CASE NO. 14292
OCCD EXHIBIT 6

Proposed Amendments To The “Pit Rule” 19.15.17 NMAC

**Energy, Minerals, and Natural Resources Department
Oil Conservation Division**

PROPOSED AMENDMENTS TO 19.15.17 NMAC

CURRENT BELOW-GRADE TANK INTERIM DESIGN 19.15.17.11.1 (5) NMAC

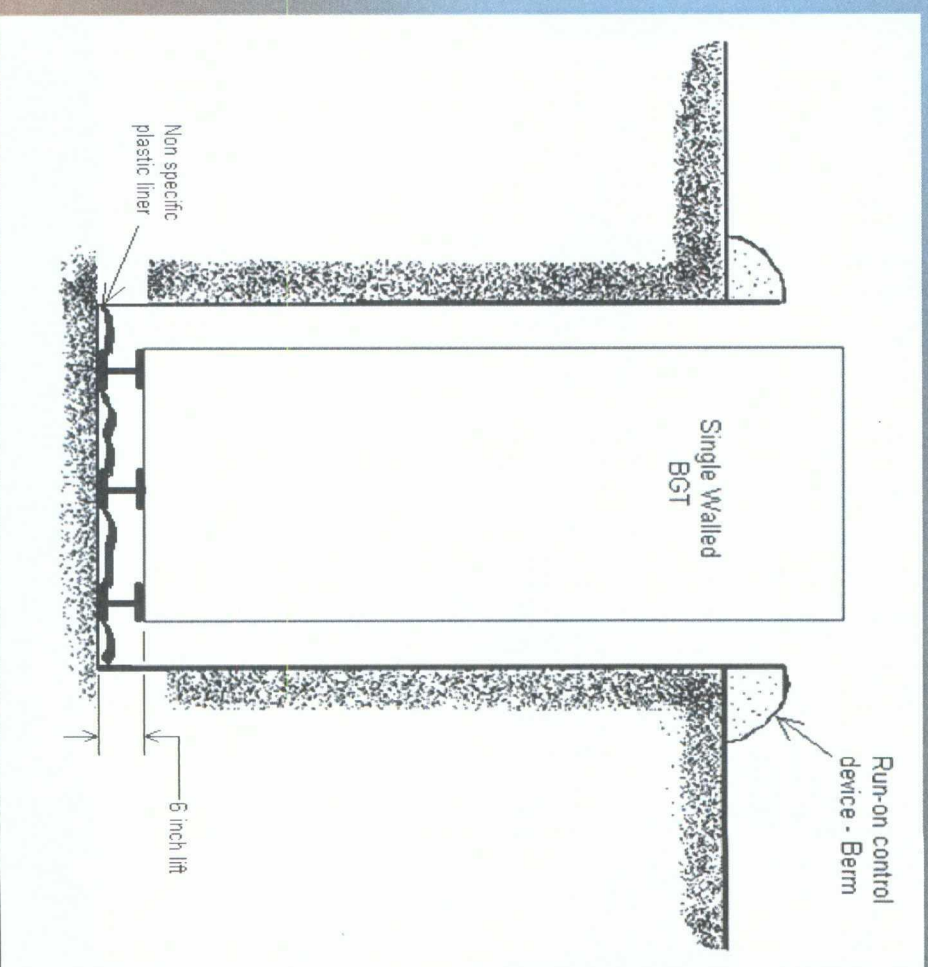
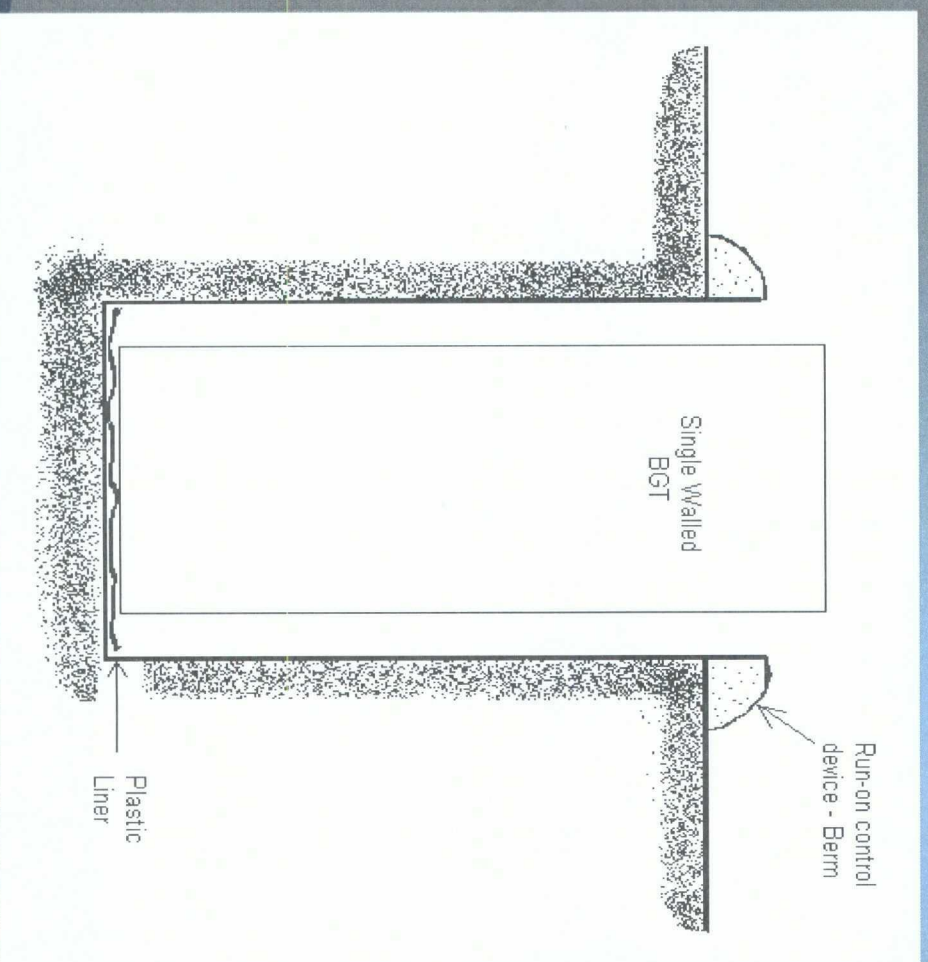
Below-grade Tanks (19.15.17.11.1 (5) NMAC):

- Below-grade tanks constructed and installed prior to June 16, 2008, that have the side walls open for visual inspection and are placed upon a geomembrane liner
 - Do not satisfy all the requirements in Paragraphs (1) through (4) of Subsection I of 19.15.17.11 NMAC.
 - Not required to equip or retrofit the below-grade tank to comply with Paragraphs (1) through (4) of Subsection I of 19.15.17.11 NMAC so long as the tank demonstrates integrity.
 - If the existing below-grade tank does not demonstrate integrity, the operator shall promptly remove that below-grade tank and install a below-grade tank that complies with Paragraphs (1) through (4) of Subsection I of 19.15.17.11 NMAC.
 - May require a permit, if not previously permitted prior to the effective date.

CURRENT BELOW-GRADE TANK INTERIM DESIGNS 19.15.17.11.1 (5) NMAC

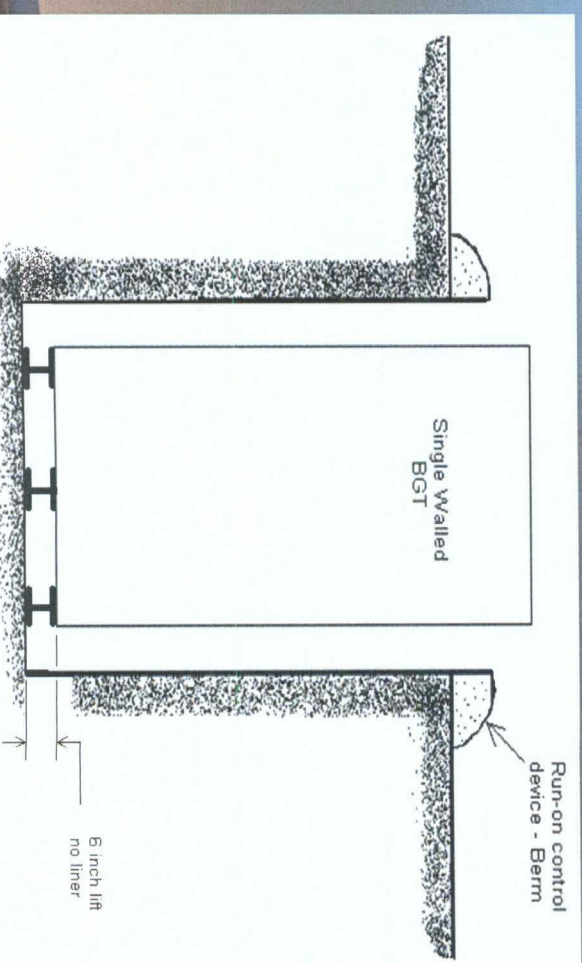
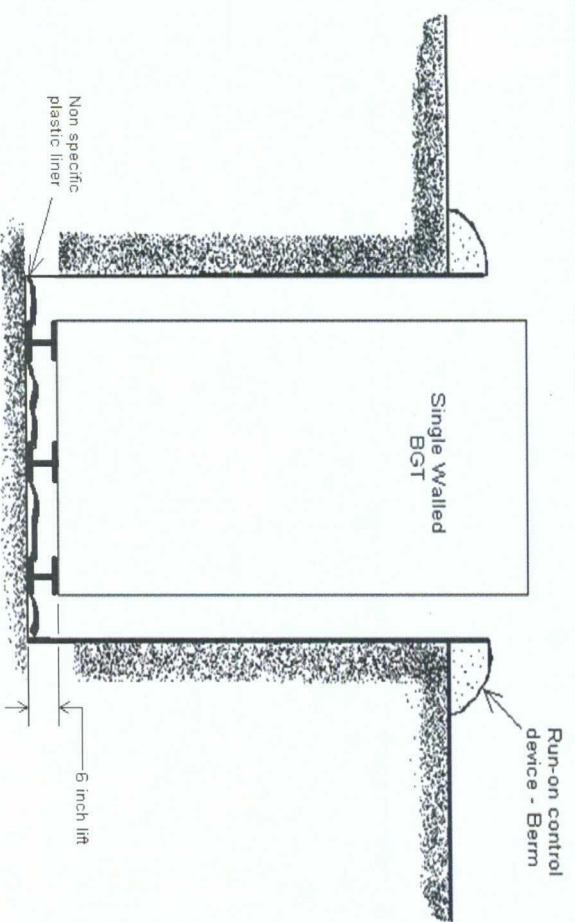
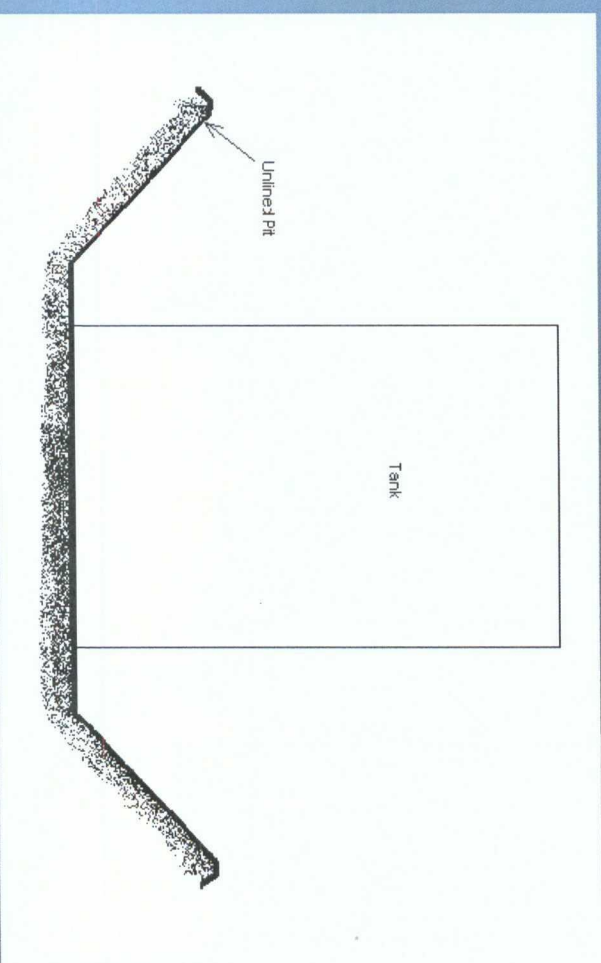
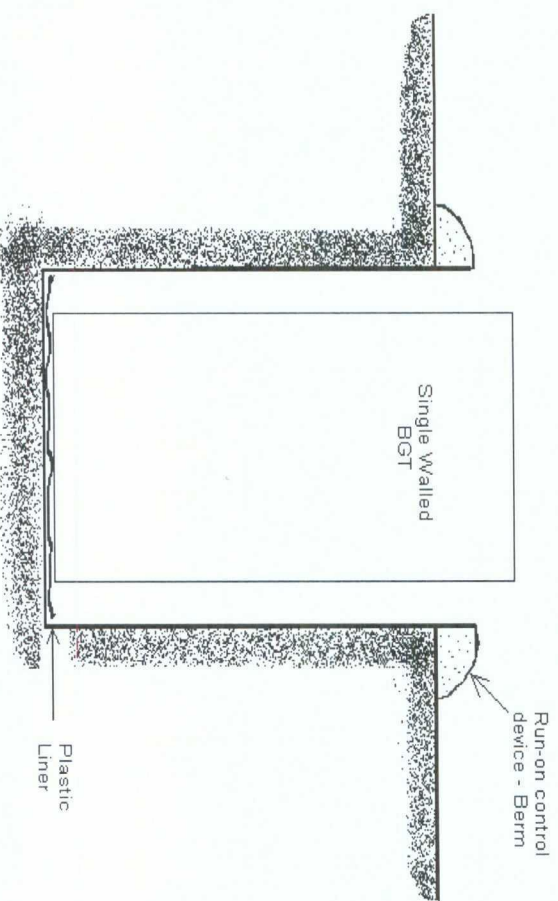
- “The operator of a below-grade tank constructed and installed prior to June 16, 2008 ~~that has the side walls open for visual inspection and is placed upon a geomembrane liner but does not meet all the requirements in Paragraphs (1) through (4) of Subsection I of 19.15.17.11 NMAC and is not included in Paragraph (6) of Subsection I of 19.15.17.11 NMAC~~ is not required to equip or retrofit the below-grade tank to comply with Paragraphs (1) through (4) of Subsection I of 19.15.17.11 NMAC so long as it demonstrates integrity. If the existing below-grade tank does not demonstrate integrity, the operator shall promptly remove that below-grade tank and install a below-grade tank that complies with Paragraphs (1) through (4) of Subsection I of 19.15.17.11 NMAC. The operator shall comply with the operational requirements of 19.15.17.12 NMAC.”

- Operators of below-grade tanks, constructed and installed prior to June 16, 2008, that have sidewalls open for visual inspection may continue to operate the tank until integrity fails or until sale or transfer, at which time the operator shall retrofit the below-grade tank.
- Only operators of below-grade tanks, constructed and installed prior to June 16, 2008, that are singled walled and have any portion of the tank's sidewall below the ground surface and not visible are required to retrofit the tank to comply with an approved design or close the tank, within five years of June 16, 2008, if the tank's integrity fails, or until sale or transfer, whichever occurs first.
- The amendments also specify that operators must comply with the operational requirements, especially the amendments that address integrity failures, releases, and retrofits.

CURRENT BELOW-GRADE TANK DESIGN THAT REQUIRES RETROFIT OR CLOSURE 19.15.17.11.I (6) NMAC

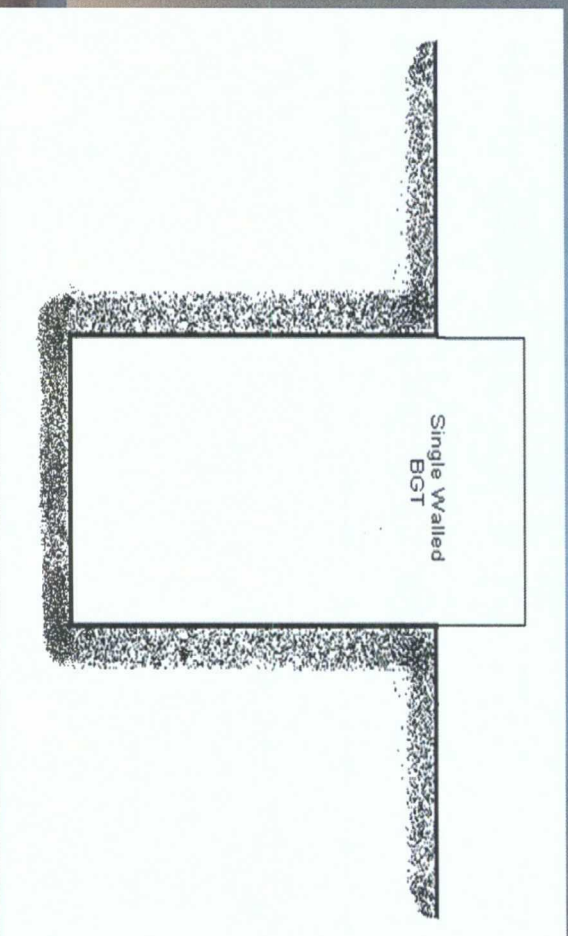
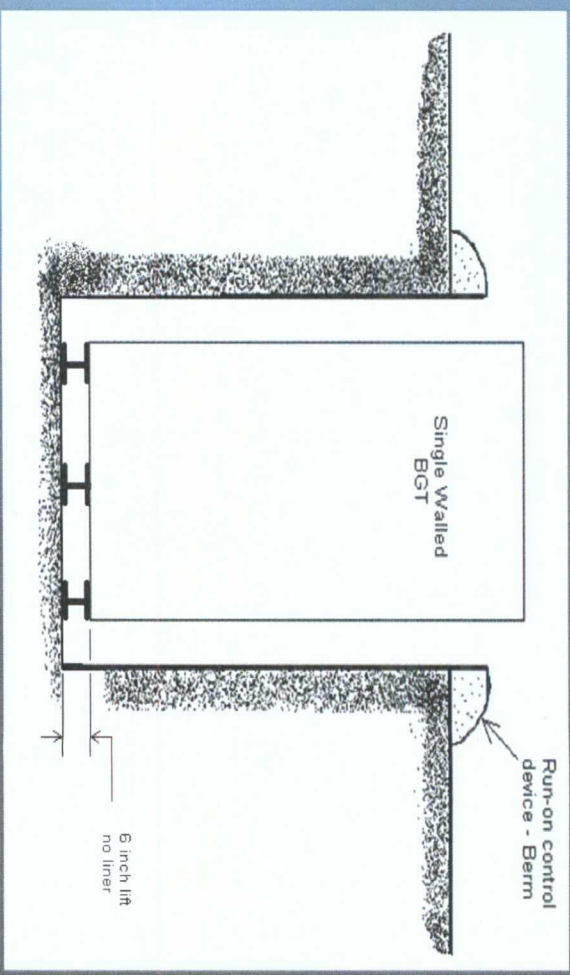
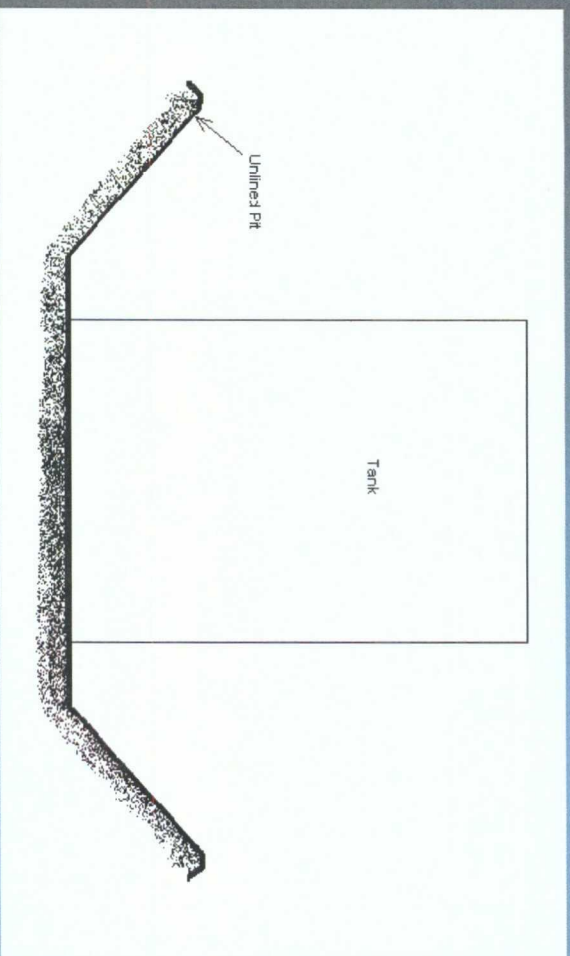
Below-grade Tanks (19.15.17.11.I (6) NMAC):

- Below-grade tanks constructed and installed prior to June 16, 2008, that do not comply with Paragraphs (1) through (4) of Subsection I of 19.15.17.11 NMAC or that do not comply with Paragraph (5) of Subsection I of 19.15.17.11 NMAC.
 - Shall equip or retrofit the below-grade tank to comply with Paragraphs (1) through (4) of Subsection I of 19.15.17.11 NMAC, or close the tank, within five years after June 16, 2008.
 - If the existing below-grade tank does not demonstrate integrity, the operator shall promptly remove that below-grade tank and install a below-grade tank that complies with Paragraphs (1) through (4) of Subsection I of 19.15.17.11 NMAC or close it.
 - May require a permit, if not previously permitted prior to the effective date.

DESIGN (THAT REQUIRES RETROFIT OR CLOSURE)
19.15.17.11.1 (6) NMAC

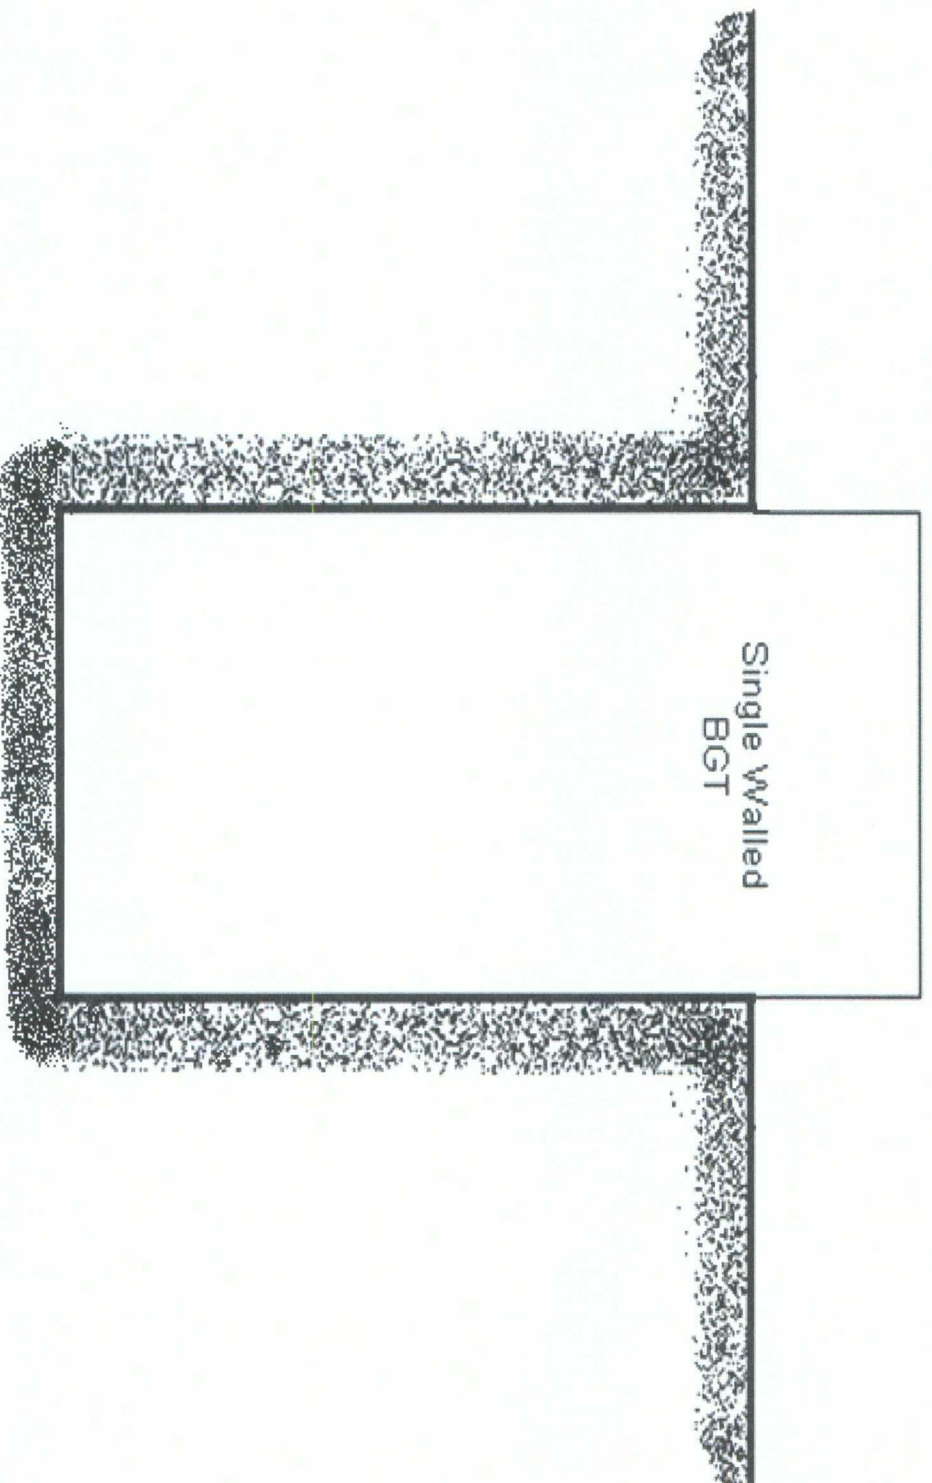
- “The operator of a below-grade tank constructed and installed prior to June 16, 2008 that ~~does not comply with Paragraph (1) through (4) of Subsection 1 of 19.15.17.11 NMAC or that does not comply with~~

~~Paragraph (5) of Subsection 1 of 19.15.17.11 NMAC~~ is singled walled and where any portion of the tank sidewall is below the ground surface and not visible shall equip or retrofit the below-grade tank to comply with Paragraphs (1) through (4) of Subsection 1 of 19.15.17.11 NMAC, or close it, within five years after June 16, 2008. If the existing below-grade tank does not demonstrate integrity, the operator shall promptly remove that below-grade tank and install a below-grade tank that complies with Paragraphs (1) through (4) of Subsection 1 of 19.15.17.11 NMAC. The operator shall comply with the operational requirements of 19.15.17.12 NMAC.”

- To allow operators that were proactive and installed a design that allowed for a larger portion of the below-grade tank to be inspected for leaks to continue to operate until the tank's integrity fails or until the tank is sold or transferred. Thus, deferring the closure and retrofit costs until action is required and not within five years of June 16, 2008, as currently required.
- To address operators of below-grade tanks constructed and installed prior to June 16, 2008, that did not obtain permits or install tanks that comply with the design and construction requirements of Rule 50 (secondary containment and leak detection). Such operators will be required to retrofit the tank to comply with a approved design or close the tank, within five years of June 16, 2008 or when the tank's integrity fails, whichever occurs first.
